VALUE ENGINEERING STUDY

Project # IMNH0-0285-01(352) PI No. 713300-

I-285 at Bouldercrest Road Interchange
DeKalb County, Georgia

23 February 2012

PROPOSAL NUMBER: R-1.0

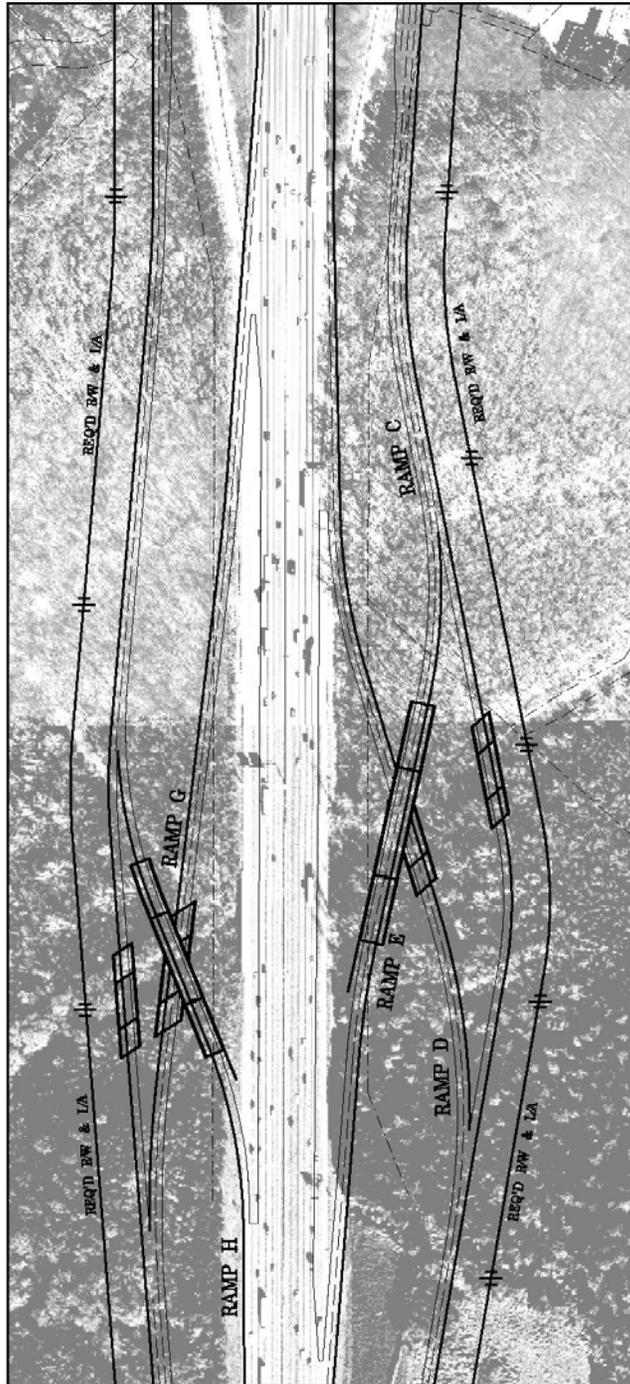
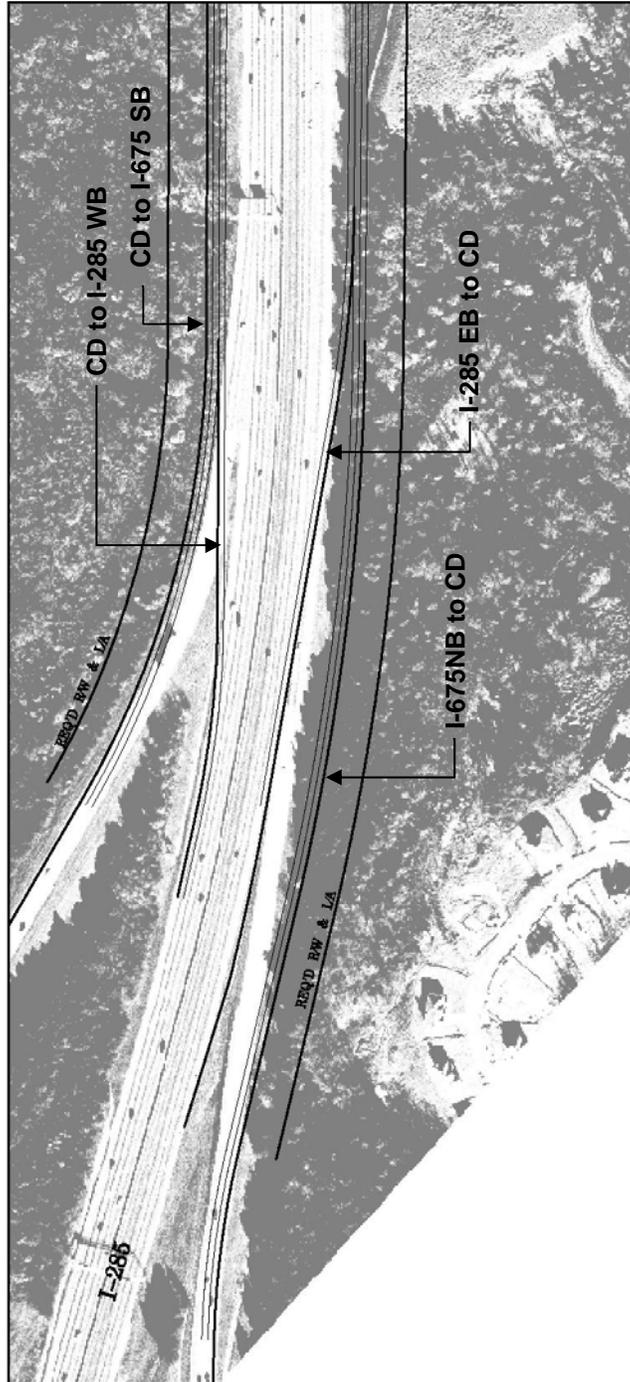
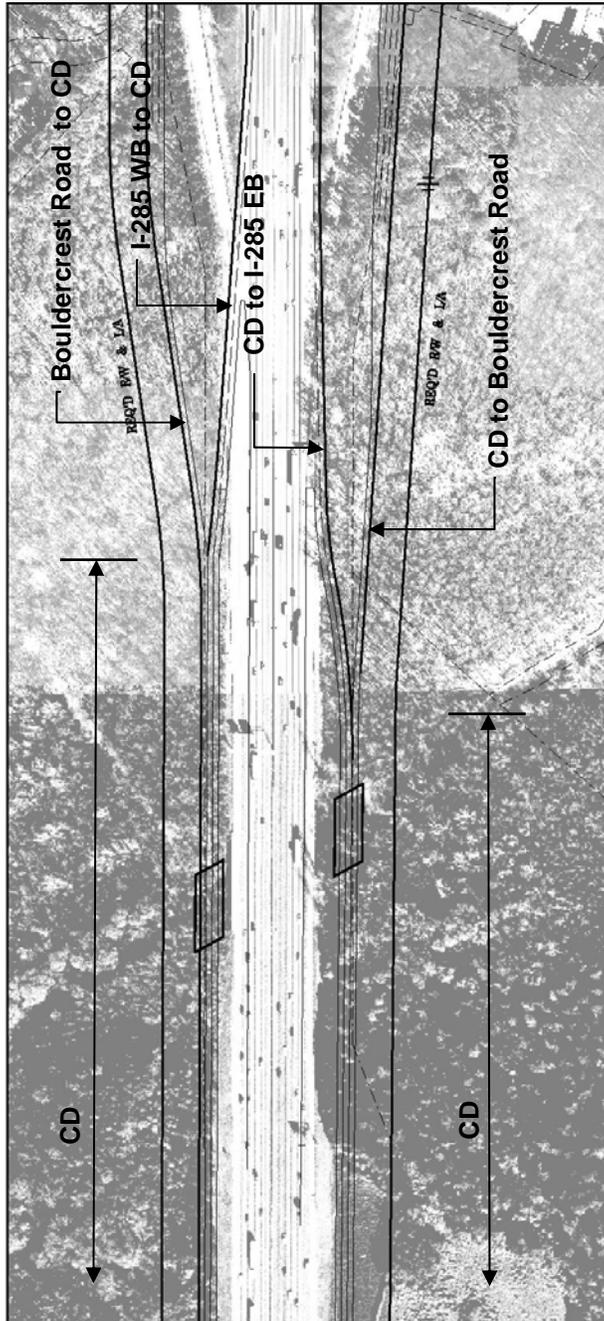
PROPOSED CHANGE: It is proposed to combine the ramps from I-675 to I-285 and Bouldercrest Road and the ramp from I-285 to Bouldercrest Road into a combined CD system. Provide a length of CD system that provides a weaving distance that meets or exceeds the minimum length required. Reduce the number of bridge crossings of South River to one combined bridge on each side of I-285.

There is sufficient distance to provide a combined CD system that allows for the required vehicular movements. The CD system approach provides all required movements and results in a significant reduction in R/W acquisition.

PROPOSAL NUMBER: R-1.1

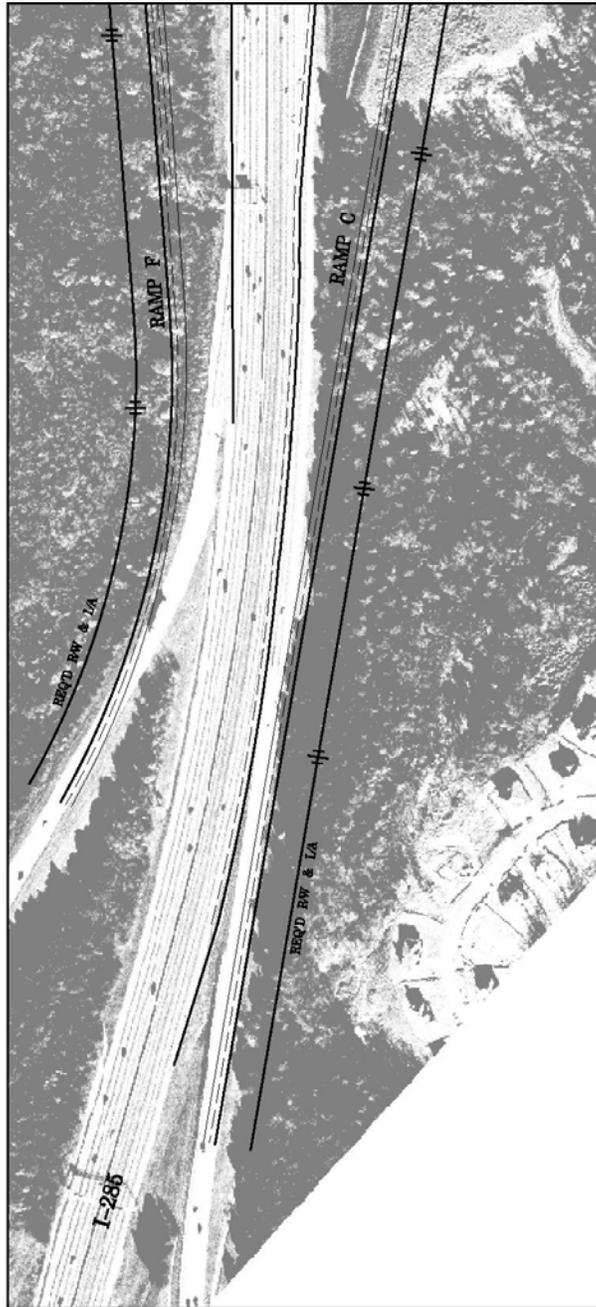
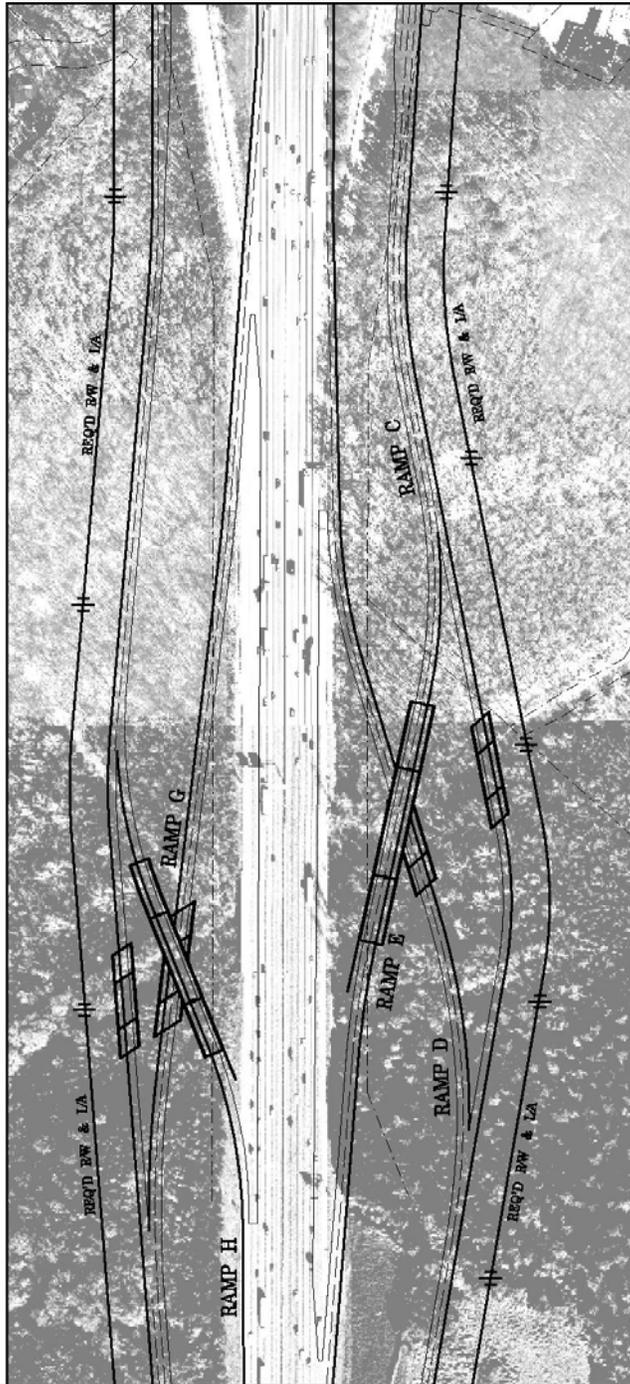
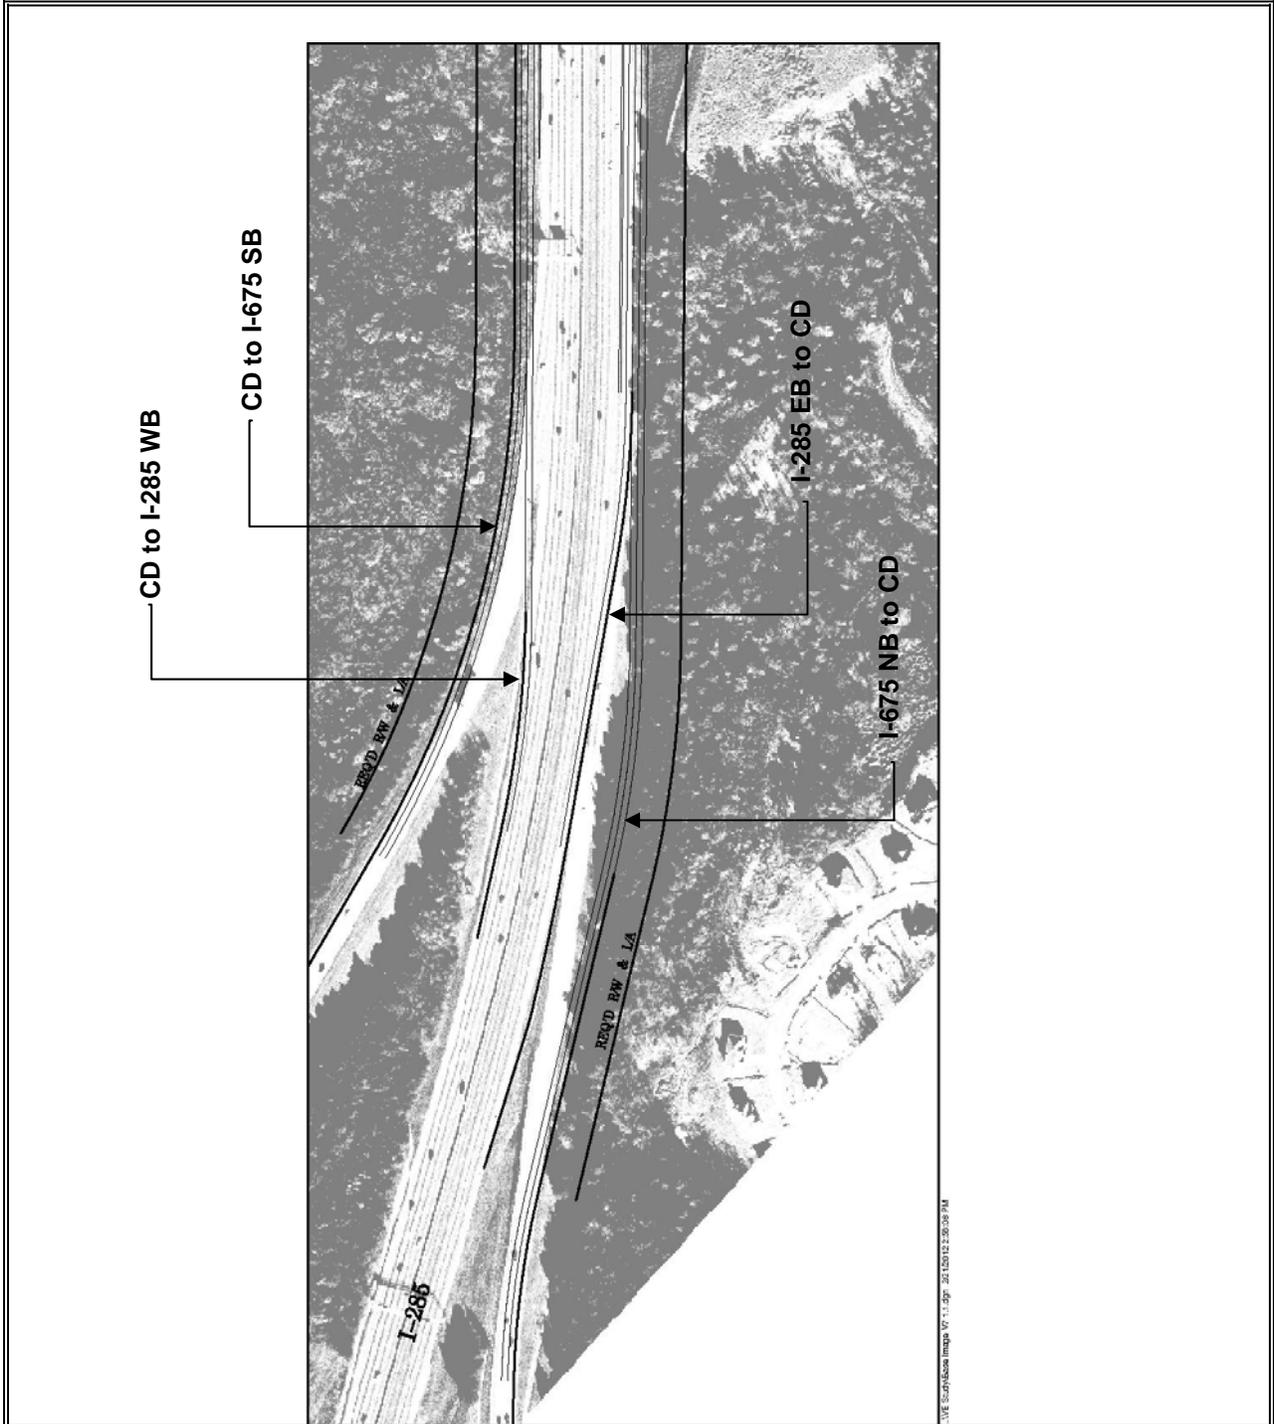
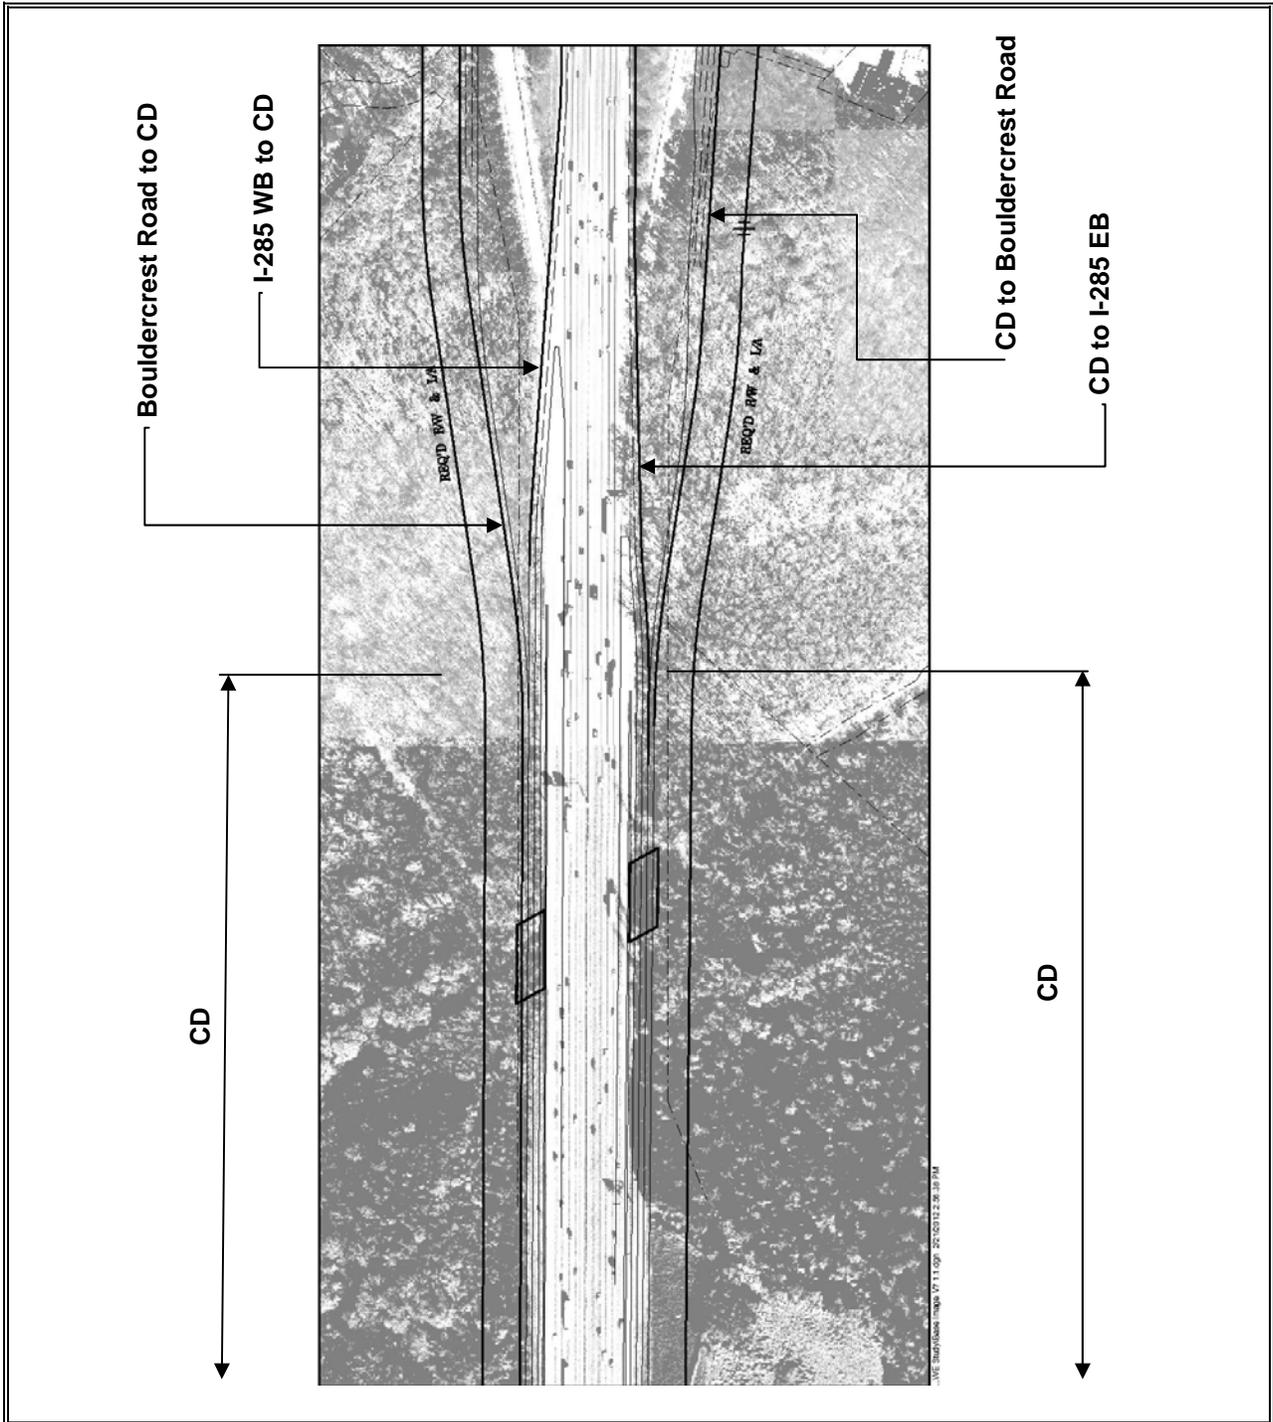
PROPOSED CHANGE: It is proposed to combine the ramps from I-675 to I-285 and Bouldercrest Road and the ramp from I-285 to Bouldercrest Road into a combined CD system. Provide a length of CD system that provides a weaving distance that meets or exceeds the minimum length required. Reduce the number of bridge crossings of South River to one combined bridge widening of the existing I-285 bridge on each side of I-285.

There is sufficient distance to provide a combined CD system that allows for the required vehicular movements. The CD system approach provides all required movements and results in a significant reduction in R/W acquisition.

PROPOSAL NUMBER: R-2.0

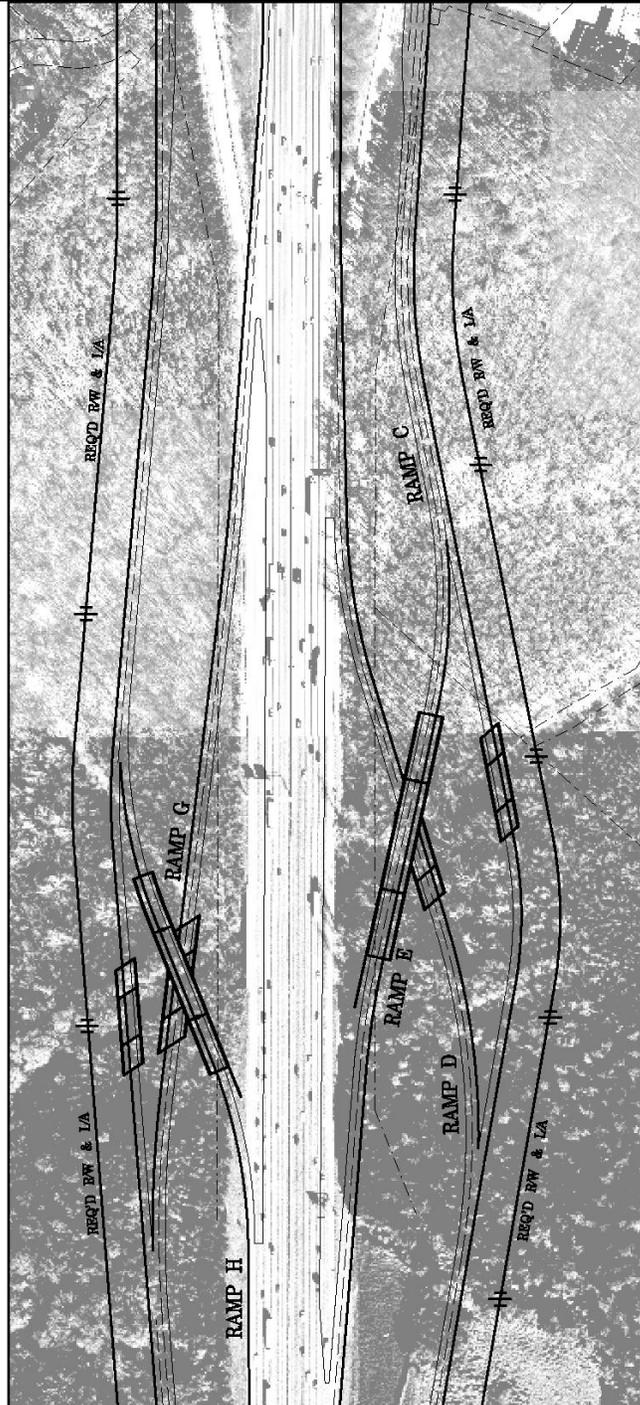
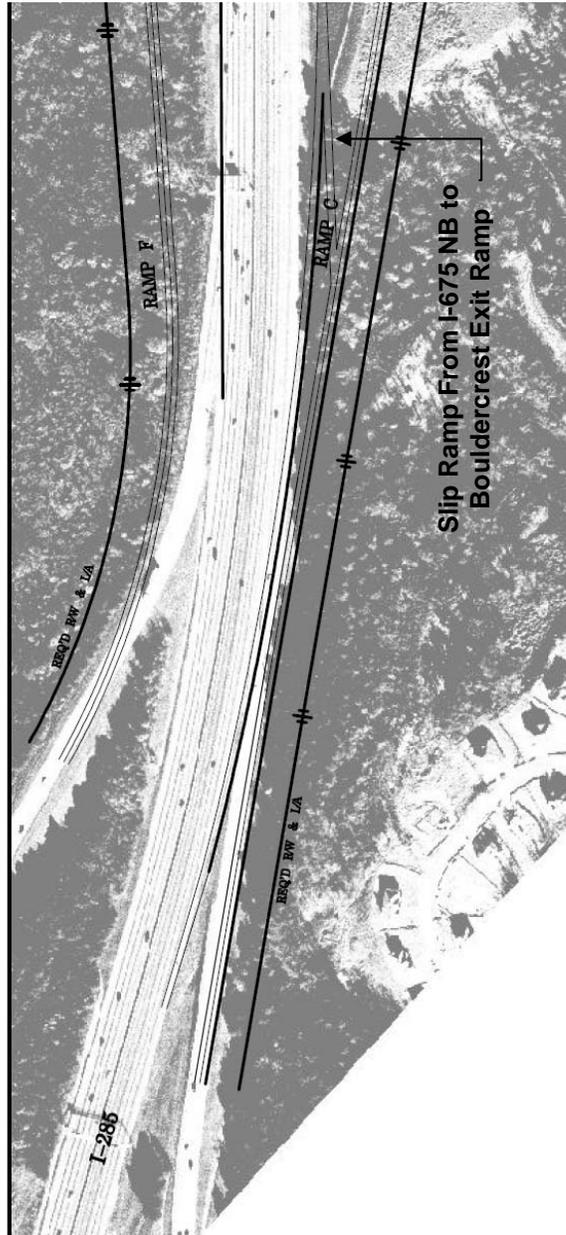
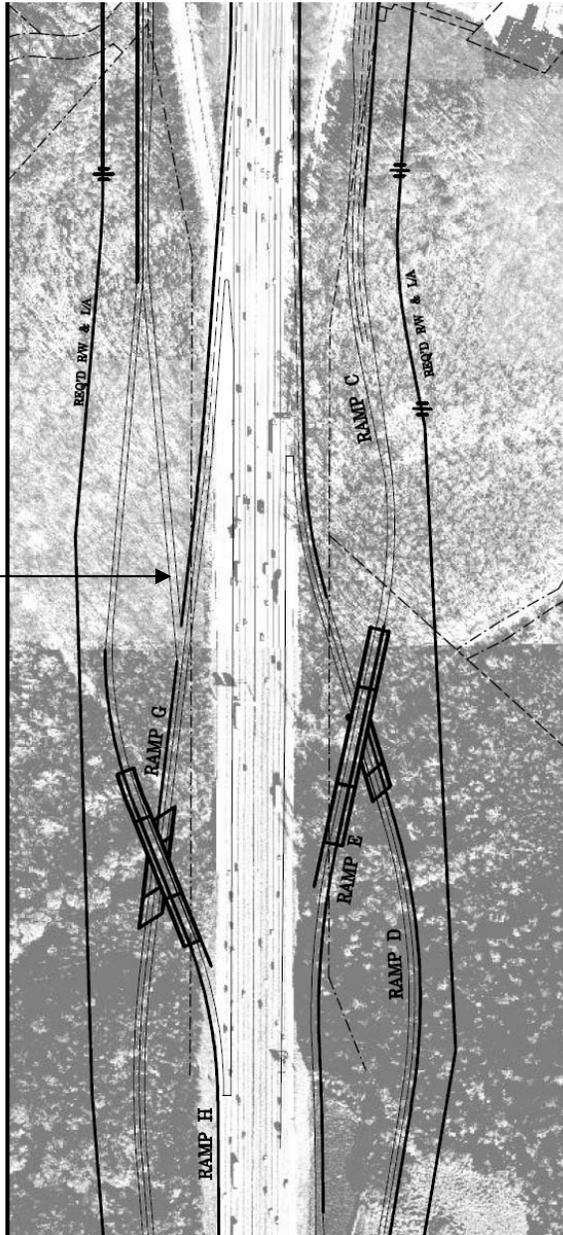
PROPOSED CHANGE: It is proposed to merge the I-675 NB to Bouldercrest Road exit with the I-285 to Bouldercrest Road exit prior to crossing the South River to eliminate one bridge. Also, merge the Bouldercrest Road to I-675 SB entrance with the I-285 WB to I-675 SB entrance prior to crossing the South River to eliminate one bridge.

There is sufficient distance to combine ramp movements that allow for the required vehicular movements. The proposed alternative provides for all vehicle movements while eliminating two bridges and providing a value added savings to the project.
